Drainage Assessment - Event Parking Area.

50 Peter Brock Drive, Eastern Creek,
NSW

P2108122JR02V01

Response to DPIE RFI

DRAWING TITLE				
DRAINAGE DETAILS SHEET 1				
PROJECT NO.	PLANSET NO.	RELEASE NO.	DRAWING NO.	REVISION
P2108122	PS01	R02	PS01-E200	A

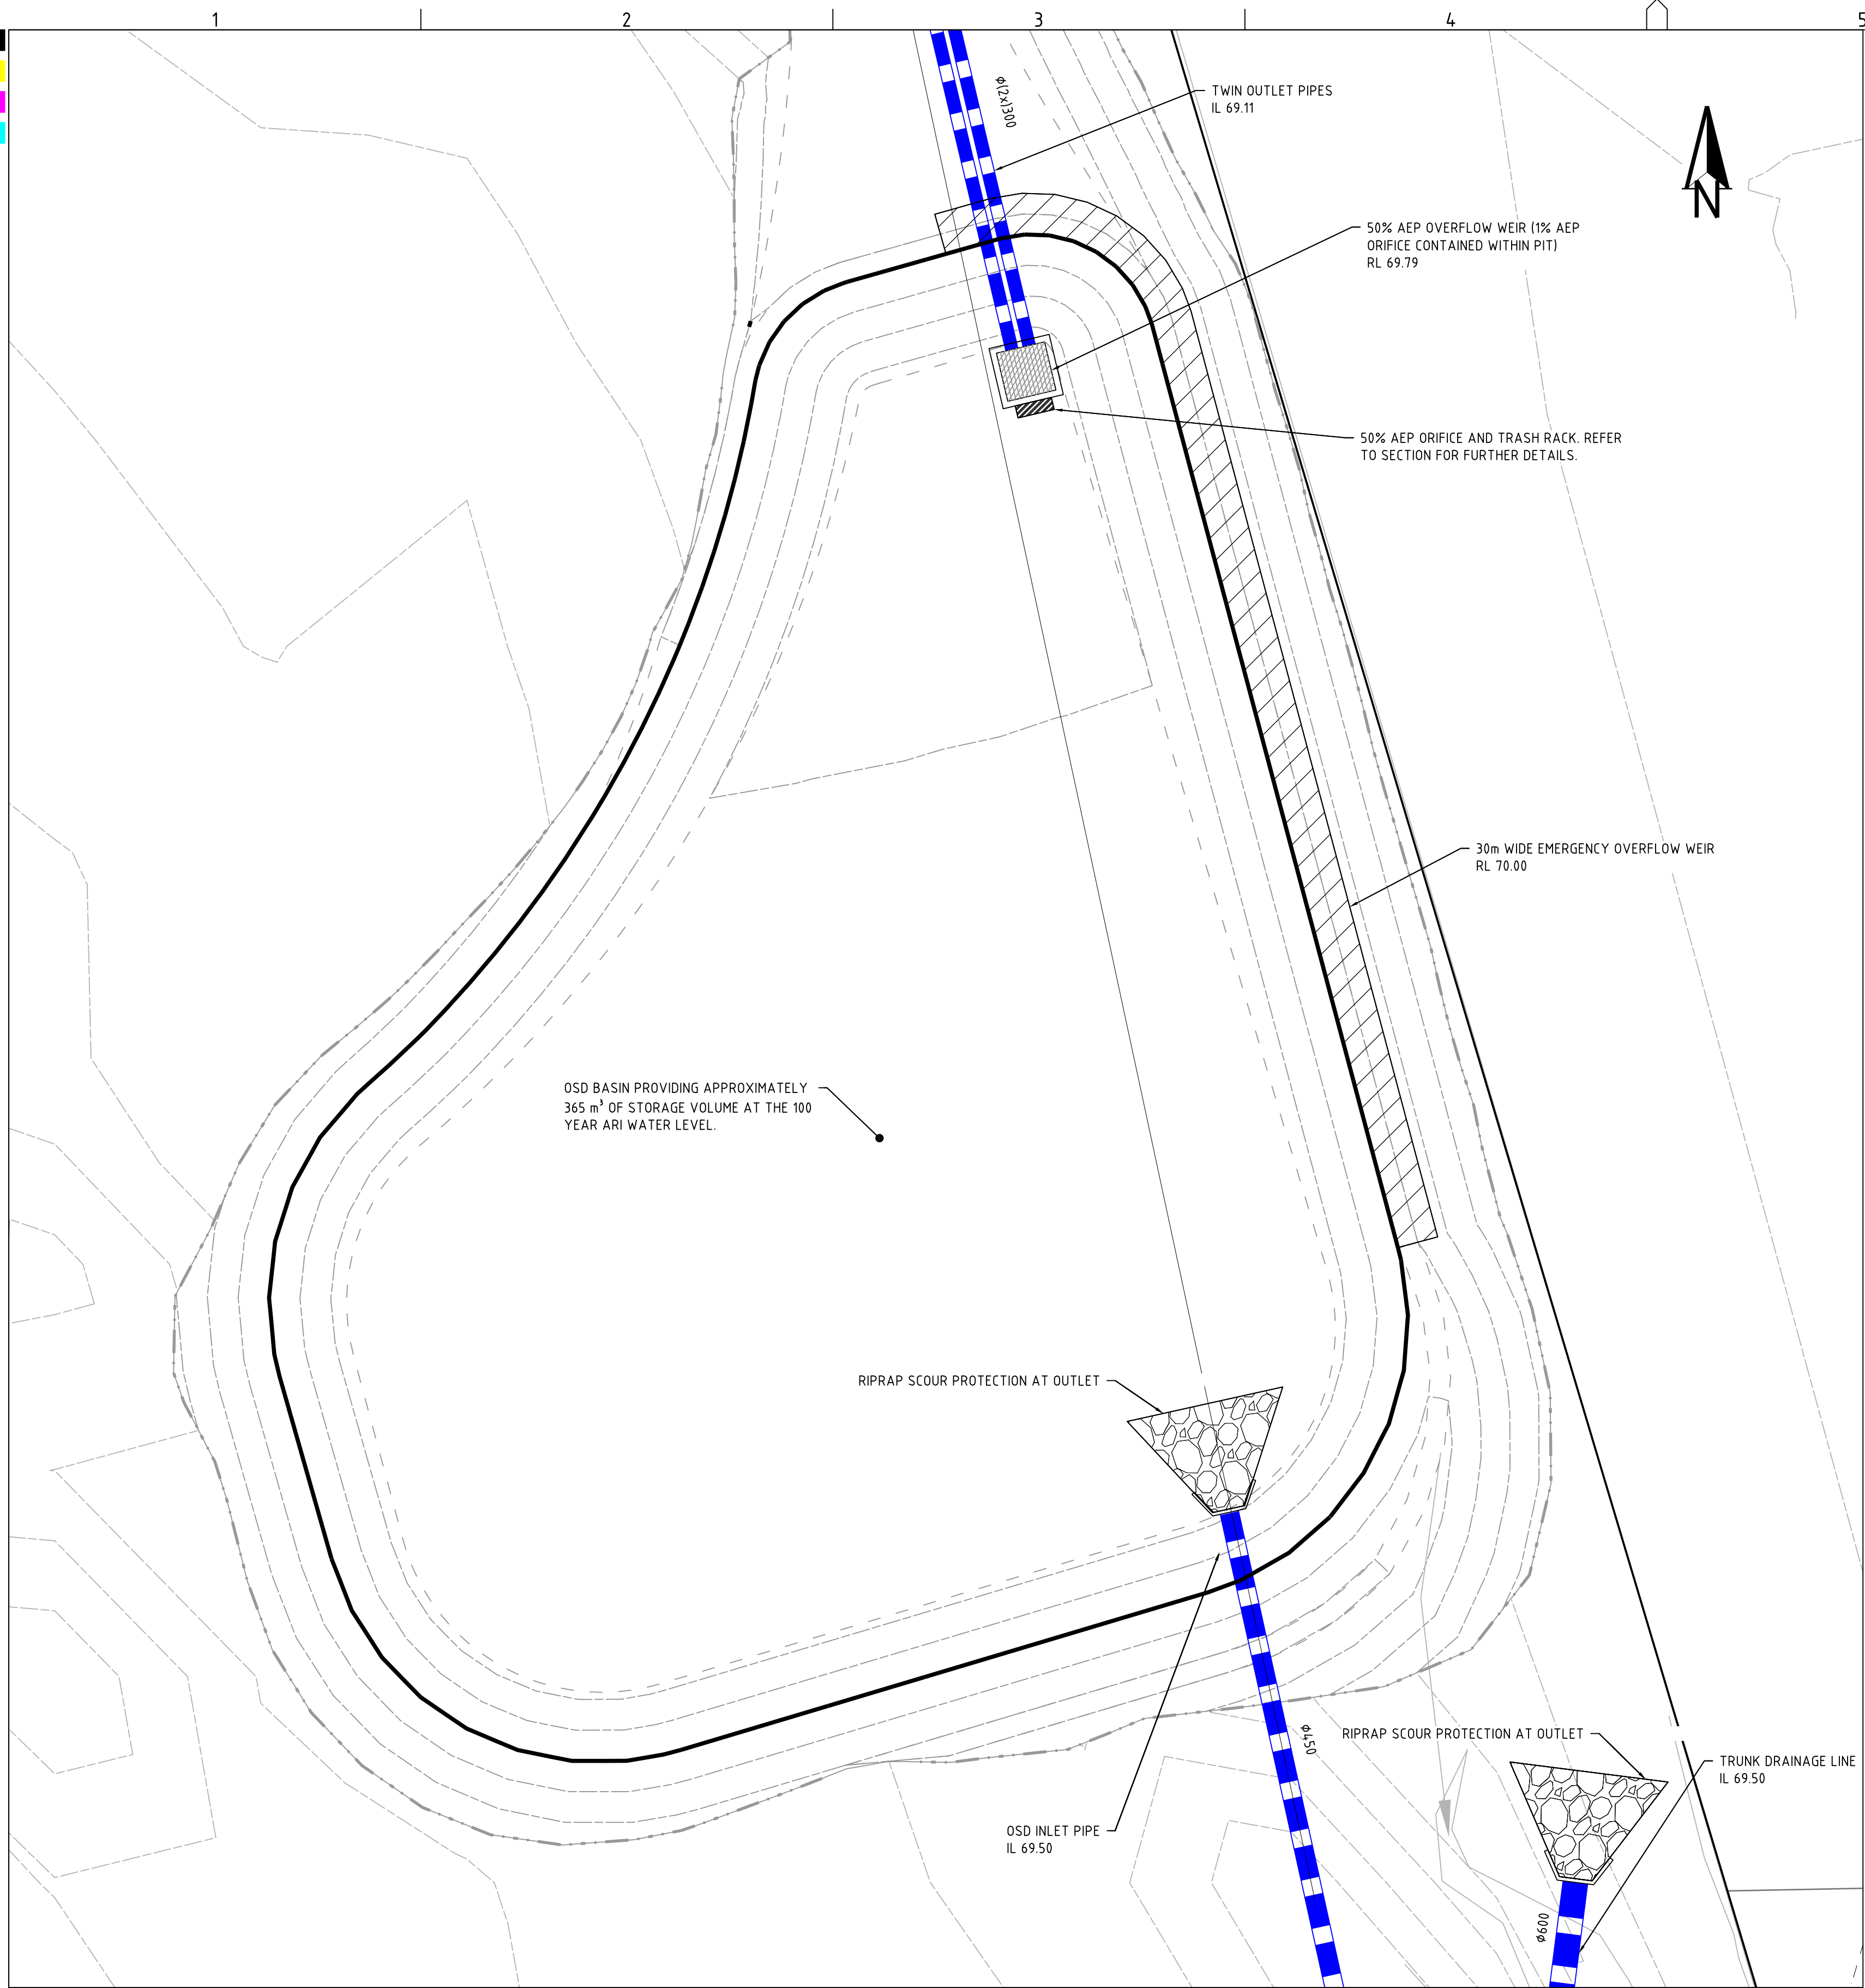
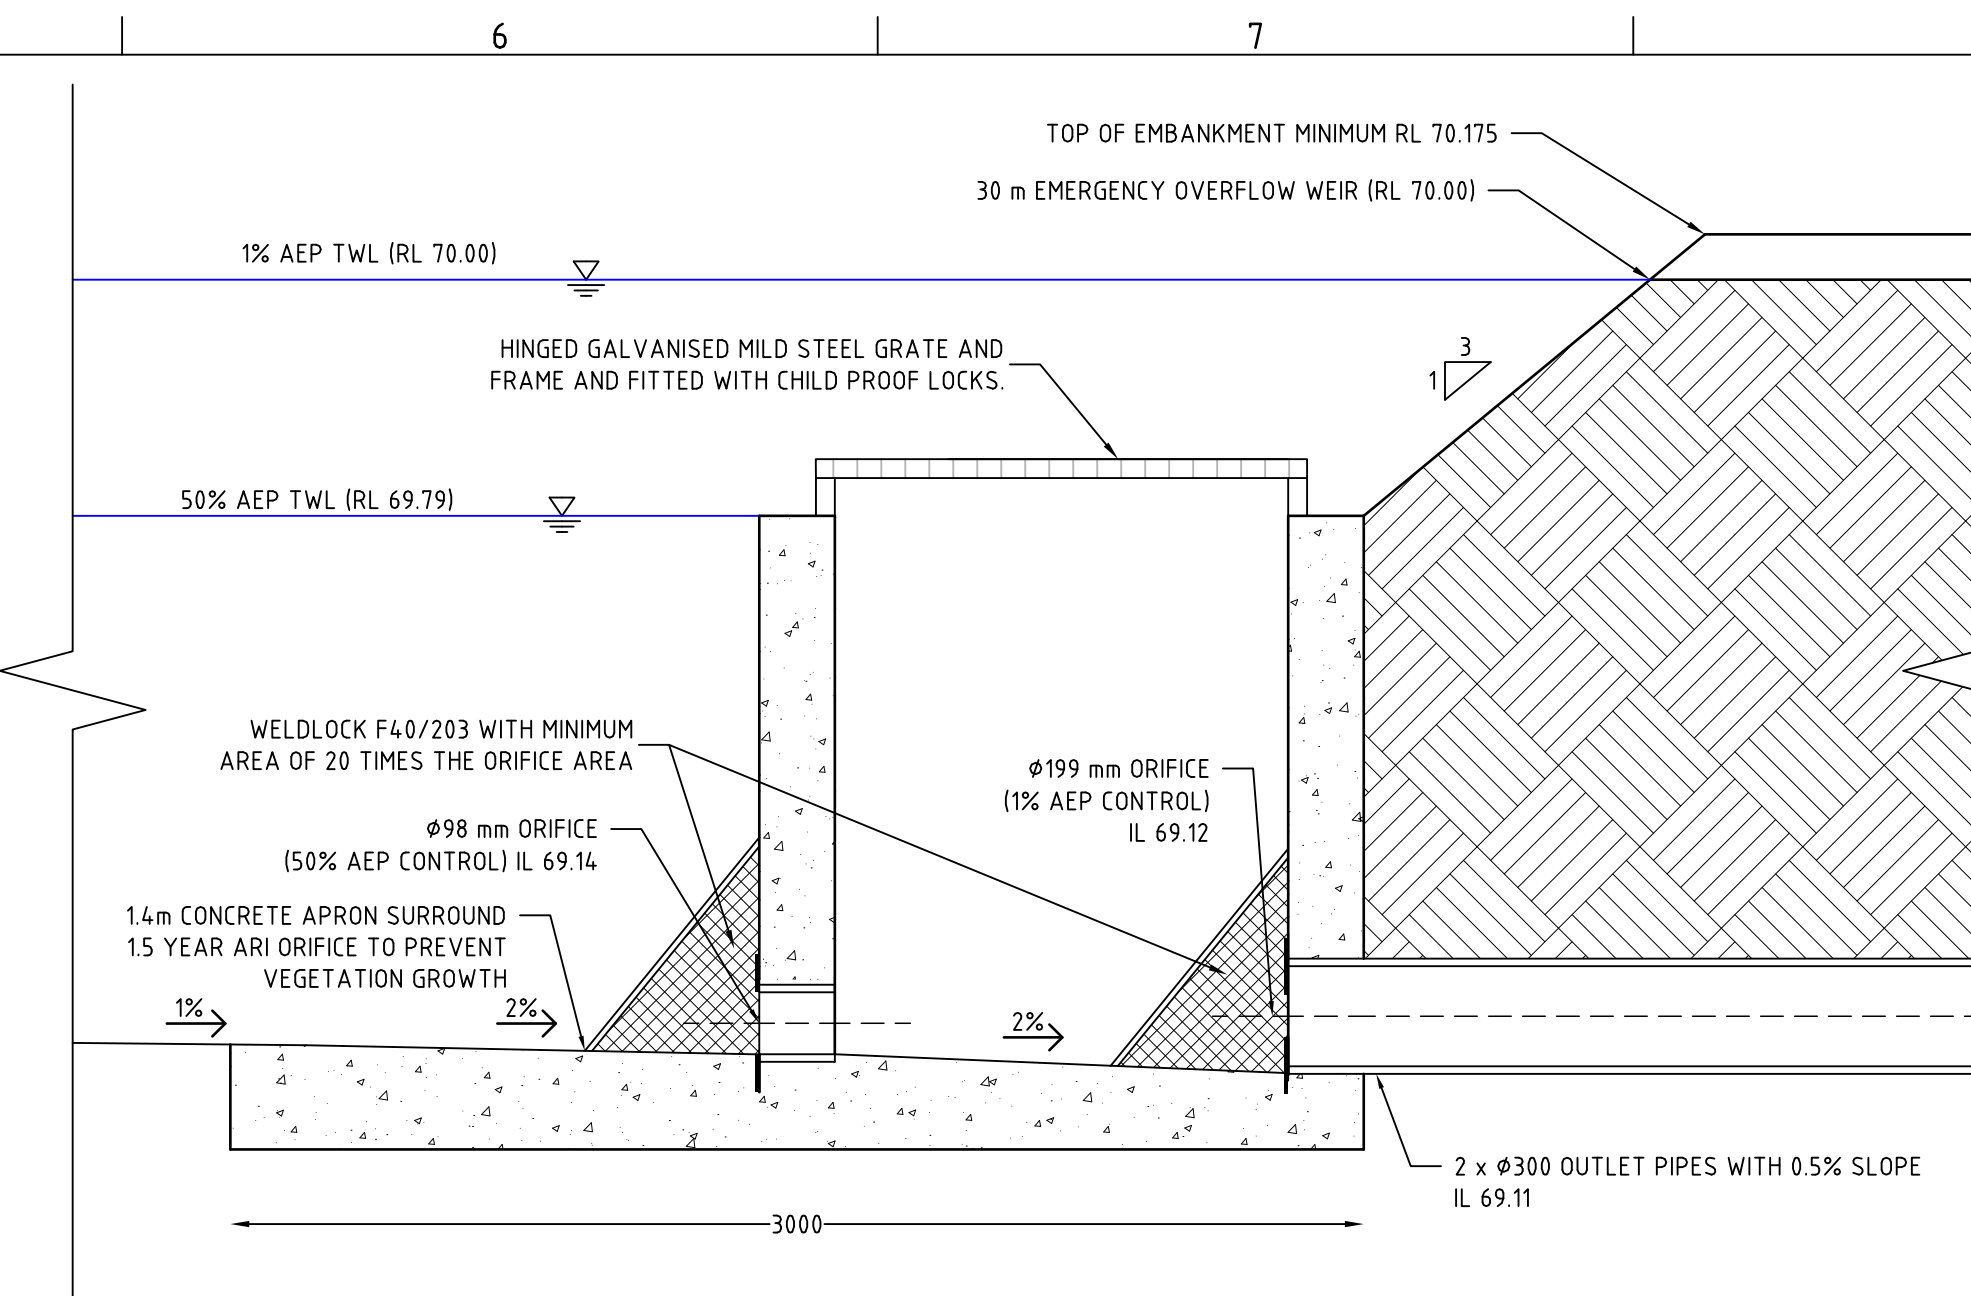
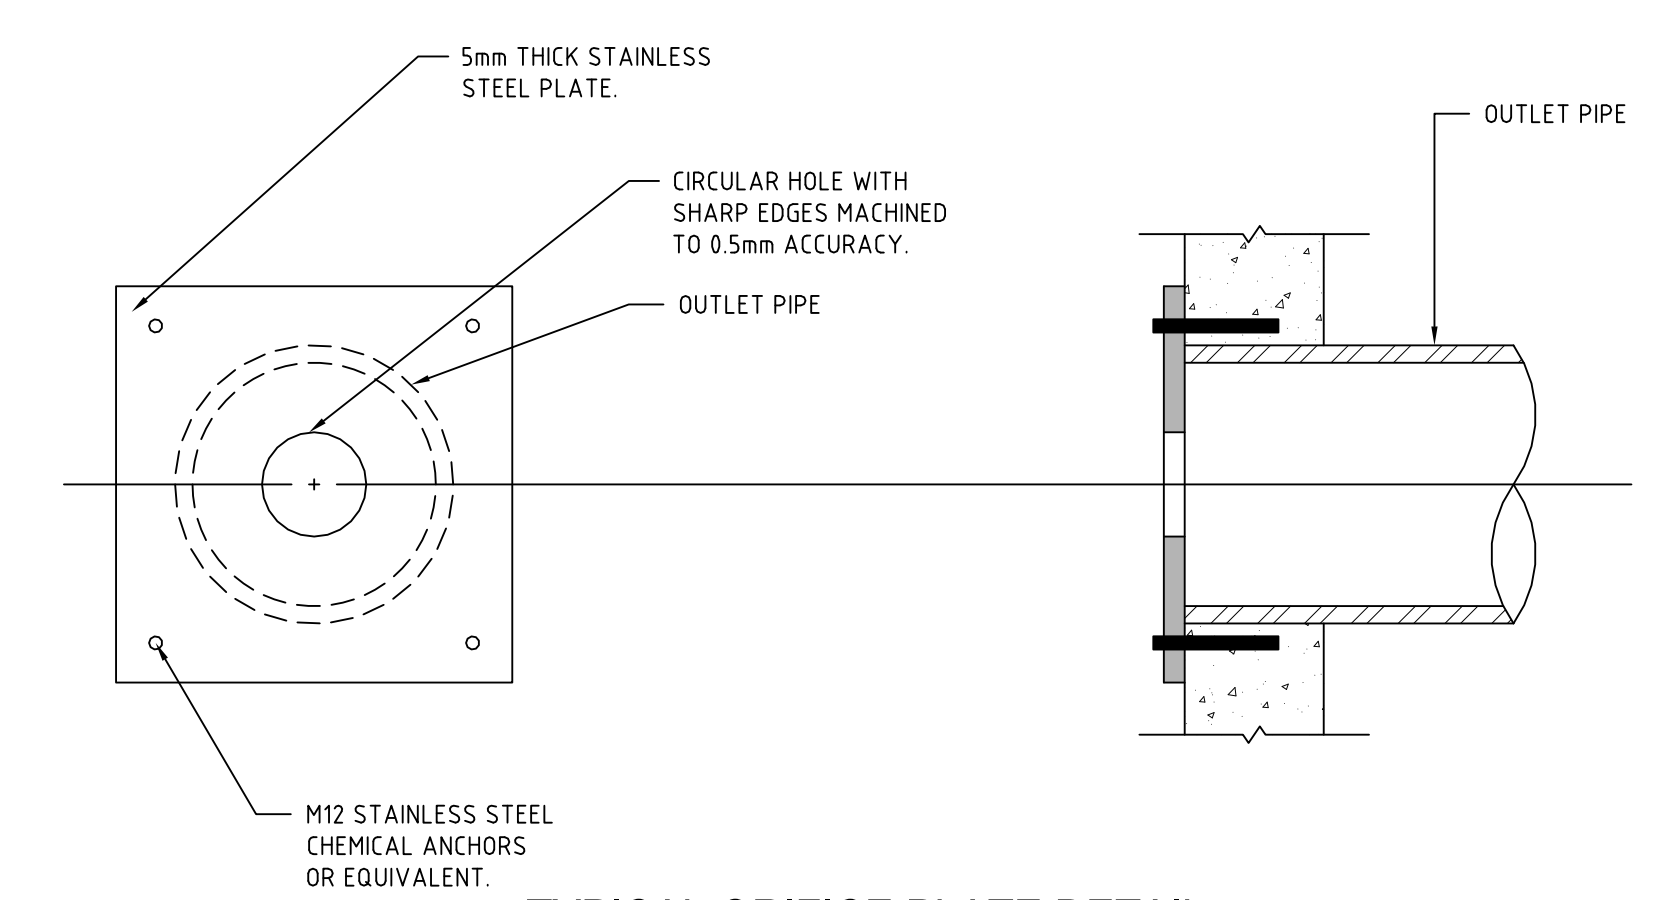
RFI Issue	Response / Comment
7.4 On-Site Detention <i>Given that gravel or bitumen sealing impacts on the previously existing impervious fraction at the subject site, impacts of increased runoff should be managed using a suitable on-site detention system designed in accordance with the Council-designated detention rate of 455 m³ per hectare or other suitable method acceptable to Council. The design of the system to be prepared by the Engineer for further consideration.</i>	OSD has been provided for the Event Parking Area in accordance with BCC's required rate of 455 m³/ha by following BCC's deemed to comply spreadsheet. Refer to Section 4 for further details.

OSD storage has been designed in accordance with BCCs deemed to comply spreadsheet tool. The site requires approximately 240 m³ for the 50% AEP storm and 365 m³ for the 1% AEP storm. Refer to Attachment C - MA planset P2108122PS01 drawing PS01-E100 for the basin location and drawing PS01-E200 for basin details.
